## **Update – Field Safety Notice**

### **MR systems with 60cm wide bore**

Quadrature Body Coil (QBC) seal adhesive failure may result in exposure of sharp edges

June 23, 2025

Figure 1. QBC seal location

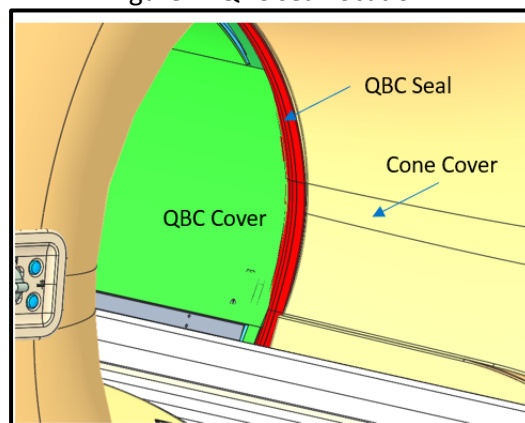
The Quadrature Body Coil (QBC) seal adhesive may fail creating sharp edges that may come in contact with patients. The QBC seal may become loose as the patient table travels in a horizontal motion in and out of the system bore. The QBC seal (Figure 1) is a rubber seal that is glued between the cone cover and QBC cover and functions to prevent sharp edges of the QBC cover from contacting patients during an examination.

If the QBC seal becomes loose during the scanning process, the risk to the patient may include one or more of the following: skin abrasions, bruises, lacerations, hair loss/entanglement, and tissue injury.

- As part of the preparation before a patient scan:
  1. Inspect the QBC seal for separation between the cone cover and QBC cover.
  2. If QBC seal is found detached or loose, **Stop-use immediately.**

Philips will contact you to schedule a time for a Field Service Engineer (FSE) to visit your site and replace your system's QBC Seal (reference FCO78100573, FCO78100615).
